UNITED STATES PATENT AND TRADEMARK OFFICE

APPLICATION NO.	FILING DATE	FIRST NAMED INVENTOR	ATTORNEY DOCKET NO.	CONFIRMATION NO.
10/571,500	03/10/2006	Mirko Milazar	2003P11268WOUS	4213
22116 7590 07/18/2008 SIEMENS CORPORATION INTELLECTUAL PROPERTY DEPARTMENT 170 WOOD AVENUE SOUTH ISELIN, NJ 08830				
EXAMINER SUNG, GERALD LUTHER				
ART UNIT		PAPER NUMBER		
3746				
MAIL DATE		DELIVERY MODE		
07/18/2008		PAPER

Office Action Summary

DETAILED ACTION

FIG. 1

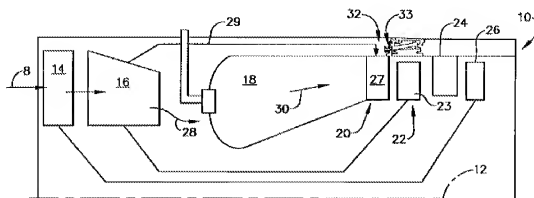
7. Regarding claims 12, 15, 18-20, and 21-22, referring to figures 1 and 4 below, as best understood, Morgan et al. disclose a axis-symmetrical gas turbine engine, with a rotationally mounted rotor (22), an axial compressor (16), a combustor (18), a turbine (23), an annular casing (44) to carry the engine's core gas flow, where a front ring like portion (refer to figure 4) extending in the axial direction and a rear ring like portion (refer to figure 4) extending in the axial direction are mounted via a seal assembly (33). The seal assembly comprises of a spring element (56) to seal off an annular gap formed by the two pieces being joined together. The downstream end of the seal assembly is attached in a groove in the rear ring like structure and the upstream end attached to a groove in the front ring like structure. When joined together via a seal assembly (33), the two ring like structures form an annular gap extending in the direction of the engine's core gas flow. Further regarding the limitation "wherein a width of the recess is smaller than a width of the spring element first portion to provide a secure retention...", Morgan et al. disclose a seal first end in a circumferential groove that is retained in the groove by a bracket 78; however, referring to figure 4 below, the seal assembly's first end is in

FIG. 4

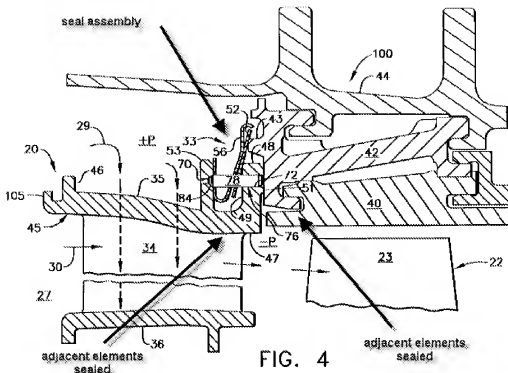
contact with both walls, where the seal will be held in place, at least in part, by the friction generated from the contact of the seal assembly on the groove. It is therefore interpreted to mean that the width of the seal's first end is greater than the width of the circumferential groove.

8. Regarding claims 13-14, Morgan et al. disclose an inner portion of the casing assembly comprising support shrouds (42) that diverge conically in the direction of the flow. The front ring like structure comprises a structure resembling a radially inner collar and the rear ring like structure comprises a structure resembling a radially outer collar.
9. Regarding claims 18-20, 24, and 27, referring to figure 4 above, Morgan et al. disclose a seal assembly bearing surface is provided on the radially inner collar on the side opposite of the engine's core gas flow. The spring component of the seal assembly is of largely S-shaped cross section. Furthermore, the cooling medium exerts a higher pressure on the outer diameter surface of the spring assembly than the inner pressure as indicated in figure 4 via +/- P.

10. Regarding claims 21-22, referring to figure 4, Morgan et al. disclose a seal assembly (33) having a first structure with a collar portion, a second structure with a collar portion adjacent to the first structure and partially overlapping so as to form an annular gap, where the second structure has a circumferential groove open to the annular gap. The spring element of the seal assembly is arranged to seal the annular gap from the engine's core gas flow such that the seal assembly is arranged to be secured within the circumferential groove and the opposite end in the contact with the upstream ring like structure portion. The circumferential groove is facing the annular gap.

13. Regarding claim 28, Morgan et al. disclose a seal assembly that "... can accommodate differential radial movement between the aft rail (48) and the hanger (42)" (column 8 lines 36-39). Referring to figure 4 above, it can be seen that the assembly structure is capable of retaining proper sealing in the event of axial movement between the first and second ring like structures.
